Detailed Site Plan Royal USA Tours

DSP-23018

REQUEST	STAFF RECOMMENDATION
Development of a 12,795-square-foot bus maintenance and operation facility and associated site improvements	With the conditions recommended herein: <ul style="list-style-type: none">• APPROVAL of Detailed Site Plan DSP-23018

STAFF REPORT

Figure 2: West, South and North Elevations (View from Top to Bottom)

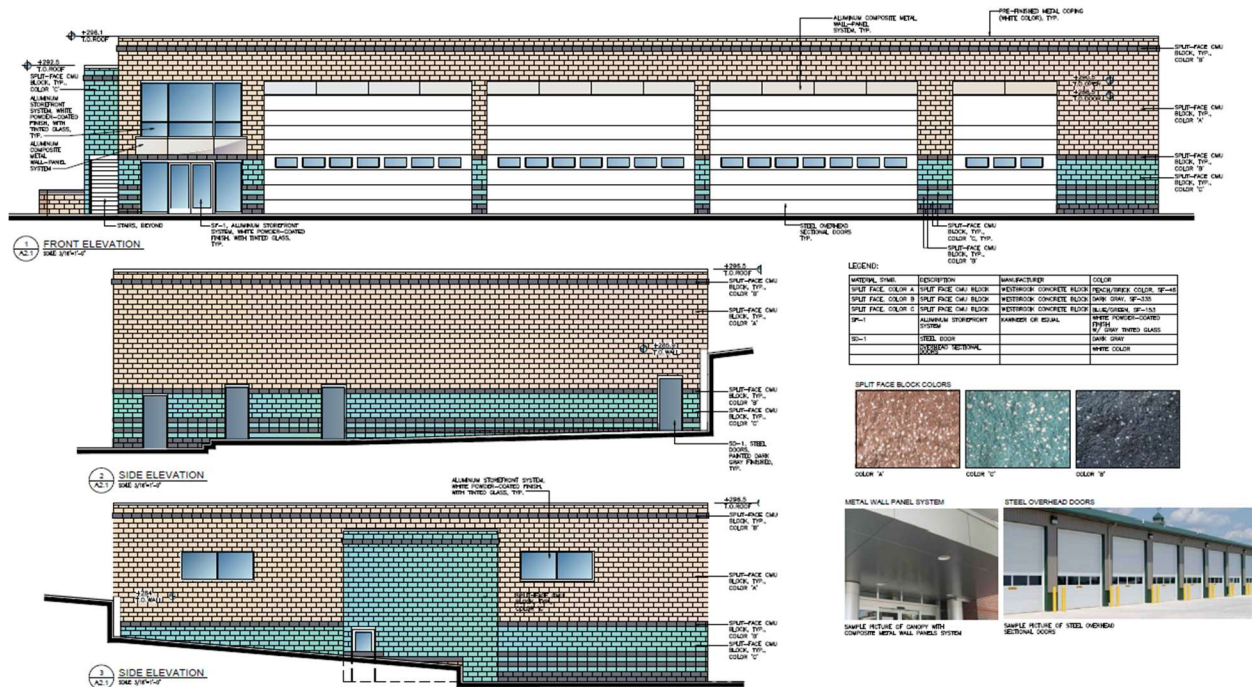
The architectural design of the proposed building will be a typical, contemporary, industrial building, generally square with a flat roof. The building is finished with a mix of materials including split-face concrete masonry unit blocks, aluminum composite metal, and glass. These building materials are proposed across all façades of the building, to ensure a unified and harmonious use of materials and style. Three different colors of concrete masonry unit blocks will create patterns to enhance the attractiveness of the building and avoid blank walls. There is a discrepancy between the building floor plan shown on Sheet DSP-4 and the south elevation shown on the architectural elevations sheet, which is conditioned herein for technical correction.

1. Prior to certification, the applicant and the applicant's heirs, successors, and/or assignees shall revise the detailed site plan, as follows:
 - a. Revise the south elevation of the proposed building to be consistent with the floor plan of the proposed building.

- b. Label the building heights on the architectural elevations.
 - c. Label the setback of the sign proposed to be mounted on the fence along Hazelwood Drive, from a street line on the plan.

One Sign mounted on Fence

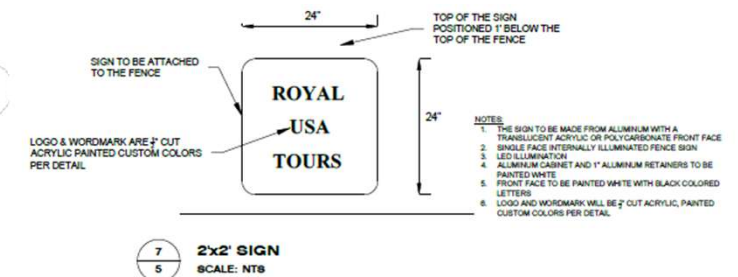
This DSP includes one sign that will be mounted on the fence along Hazelwood Drive. The sign will be made of aluminum and acrylic with internal illumination. The sign area is approximately 4 square feet. The proposed sign is in conformance with Section 27-613 of the prior Zoning Ordinance, in terms of location, height, and area, as shown on Sheets DSP-4 and DSP-5. A condition is included herein requiring the applicant to label the setback of the sign from a street line on the plan.

East retaining wall section

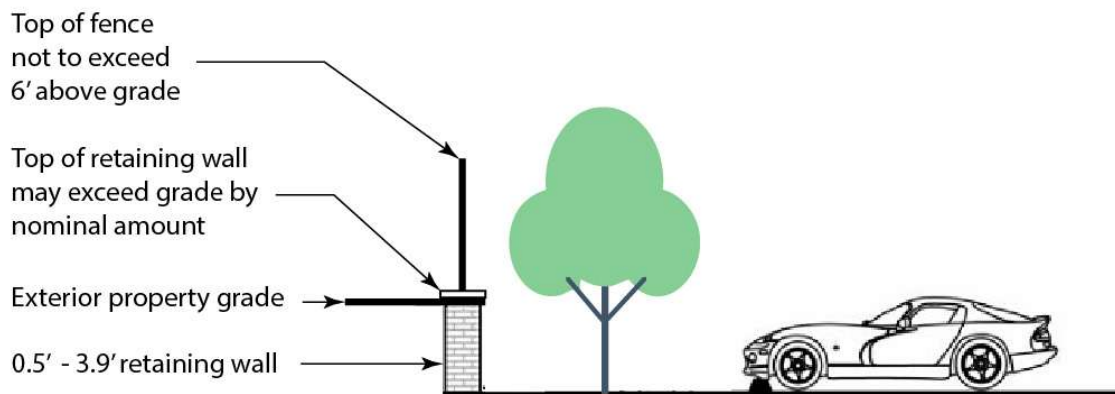
The submitted Sheet DSP-4 shows a 6-foot-tall chain-link fence is proposed along the western property line, which is in conformance with this regulation. In addition, the site plan shows a 6-foot-tall chain-link fence atop the retaining wall along the eastern property line, which will not be more than 6 feet in height measuring from the exterior property. A condition is included herein requiring the applicant to provide a section of the eastern retaining wall for this use.

- d. Correct "other offices: Accessory to a permitted use in the I-1 Zone" to "All other office" on the coversheet.
 - e. Provide sections of the fence and retaining walls along the northern and eastern property lines to show their height measuring from the exterior property not to be more than 6 feet.
